# APPENDIX THREE

T&T Ref: 85581  
05 October 2012

## 8-28 Jaunpur Crescent, Broadmeadows - Geotechnical Assessment and Peer Review

Photograph 2 Gullies and ridges above site

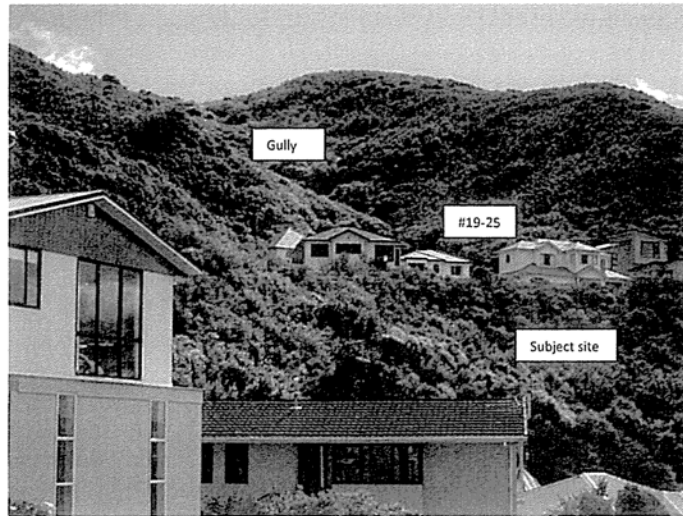
At the top of the slope is Jaunpur Crescent, and on the inside of the road are a number of houses (#19 through to #25). Behind these houses (to the west and upslope), the natural topography is one of defined gullies and ridges. A large gully runs down behind #23 and #25. The gully profile is lost on the subject site below Jaunpur Crescent.

The earthworks have resulted in cuts being made to the ridges, and filling of the gully shown in Photograph 2. The fills have extended out to allow the construction of Jaunpur Crescent. They have also been placed to re contour the upper part of the subject site.

Based on our observations, we would expect that the middle part of the site (opposite 19-25 Jaunpur Crescent) to contain the greatest thickness of fill. This is because it aligns with the centre of the large gully observed on the hillside behind (see Photograph 2).
